# TOWN OF UNDERHILL

## Development Review Board

PRELIMINARY & FINAL SUBDIVISION REVIEW

Docket #: DRB-19-10

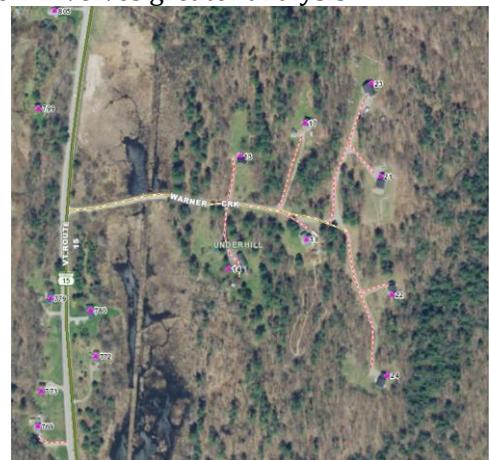
- This Staff report will review the application as if it fails to satisfy the frontage requirement since that review involves greater analysis.

- In the event that the Board finds that Lot 5B does not satisfy the frontage requirements, then the lot will be considered nonconforming, and therefore, fails to meet the dimensional standards of the Rural Residential District.
  - Frontage may be waived in accordance with §§ 3.7.F.3.a and 8.6.A.2.a.
- If the Board disagrees with Staff’s analysis and finds the Lot to be nonconforming, the Board shall **NOT** grant approval of a nonconforming lot unless the lot is part a of Planned Residential Development (Article IX).

### SECTION 3.18 – STEEP SLOPES

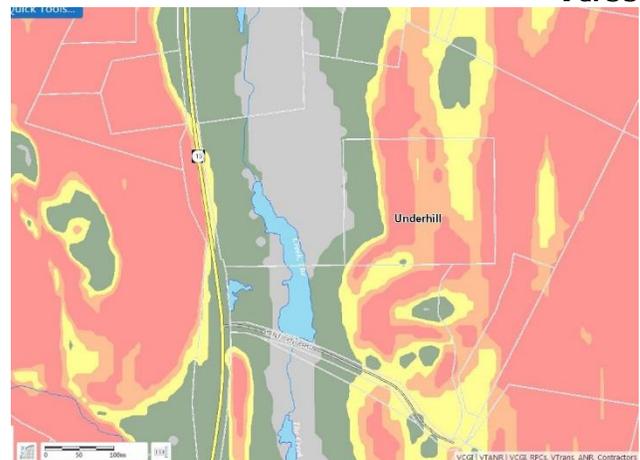
- Areas of steep slopes (15-25%) are present on the existing lot (see directly to the right).
- Based on the site plan relating to Lot 5A (see Exhibit L), in relation to the ANR Atlas Steep Slopes map (directly to the right), the site for the single-family dwelling (though for representation purposes) appears to be situated in an area that is less than 15%.
- The proposed site plan relating to Lot 5B (see Exhibit M), depicts areas of very steep slopes (>25%); however, the proposed single-family dwelling is not located in one of these areas.
  - While the proposed dwelling site is not in very steep slopes, the Board should ask the Applicant if the site contains steep slopes (15%-25%). If so, then the Board should determine whether to perform a more detailed analysis at this time

- The driveway serving Lot 5A does not appear to impact steep slopes (15%-25%) or very steep slopes (>25%), and should be verify during the site visit on September 19, 2020.
- The driveway serving Lot 5B, which will utilize an existing wood’s road, appears to impact steep slopes and very steep slopes.
  - The Applicant has provided a driveway profile (see Exhibit P); however, the Site plan does not depict a final grade of the driveway.
